## Report of the Chief Planning Officer

### *PLANS PANEL EAST*

**Subject: Application 10/03984/FU – 8 bungalows and 21 houses with landscaping at Scott Hall Square, Chapeltown, Leeds, LS7.**

**drawing title**  
Site layout

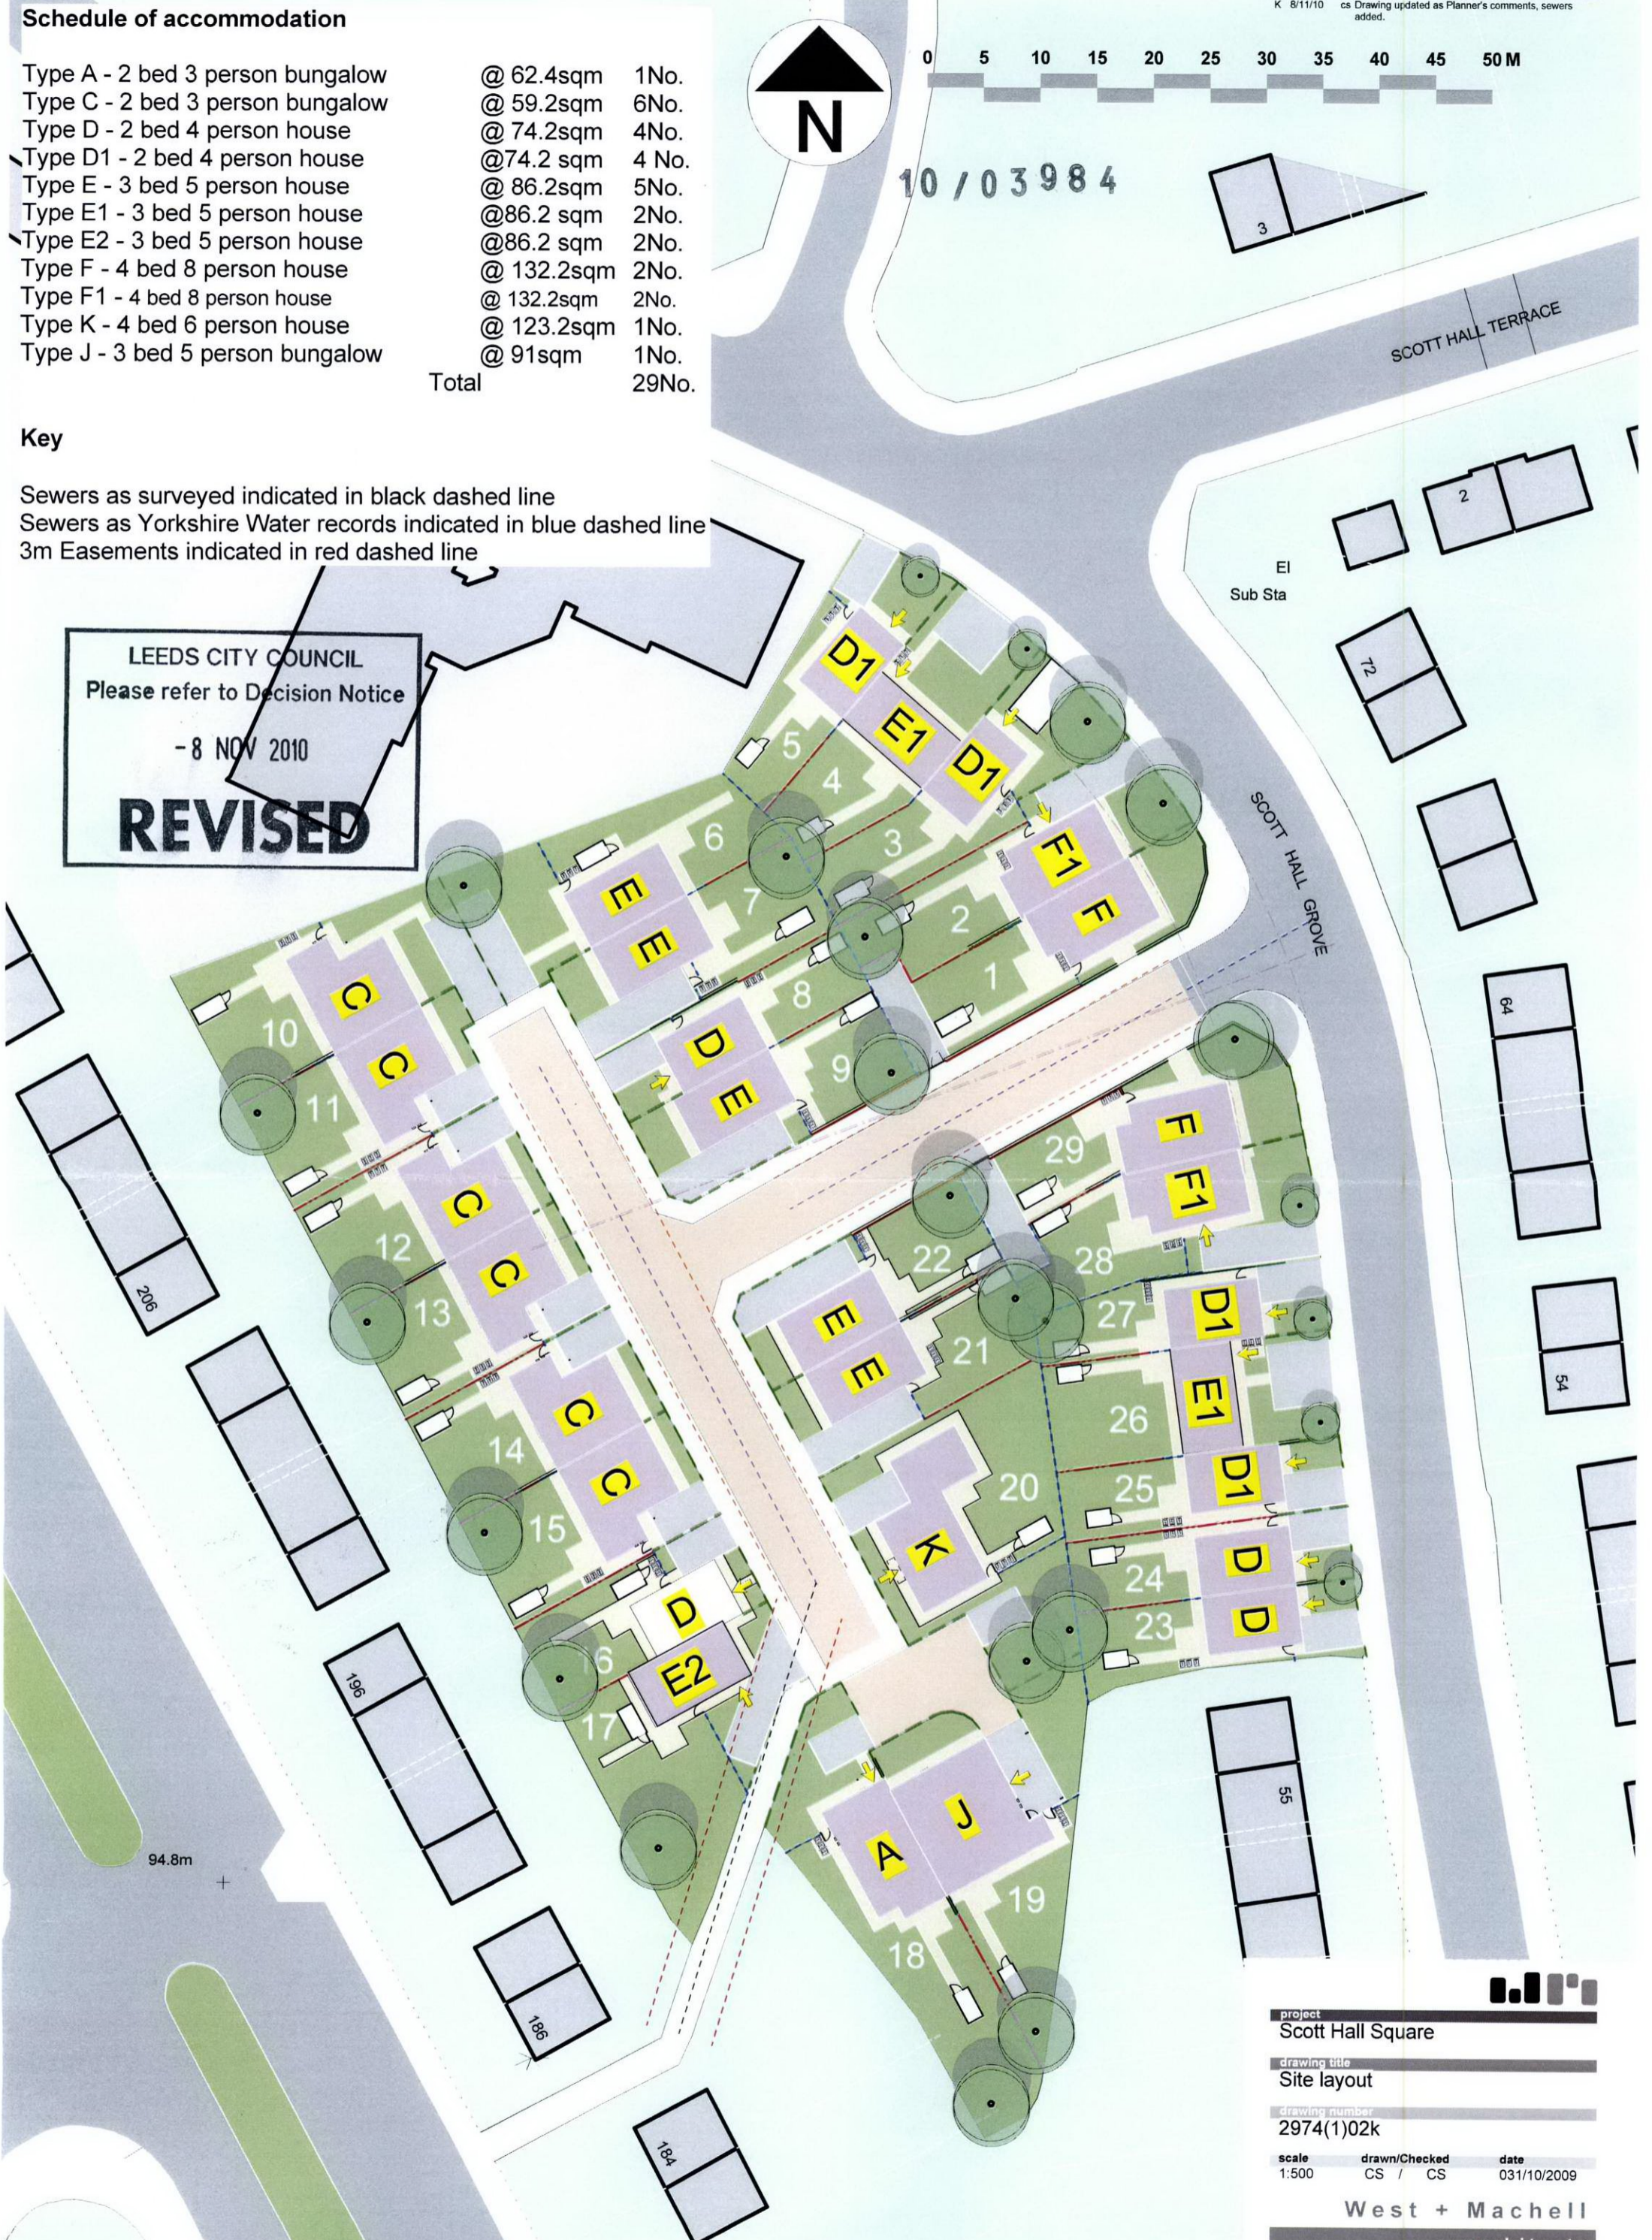
7.1 Objected to the plans as originally submitted, as the submitted plans appear to show new buildings being sited over the public sewers within the site. Additional information was requested regarding the position of sewers on site and the proposed building stand-off distances from the sewers and Yorkshire Water have now advised that they have no objections to the proposals on this basis.

revision  
K 8/11/10 cs Drawing updated as Planner's comments, sewers added.
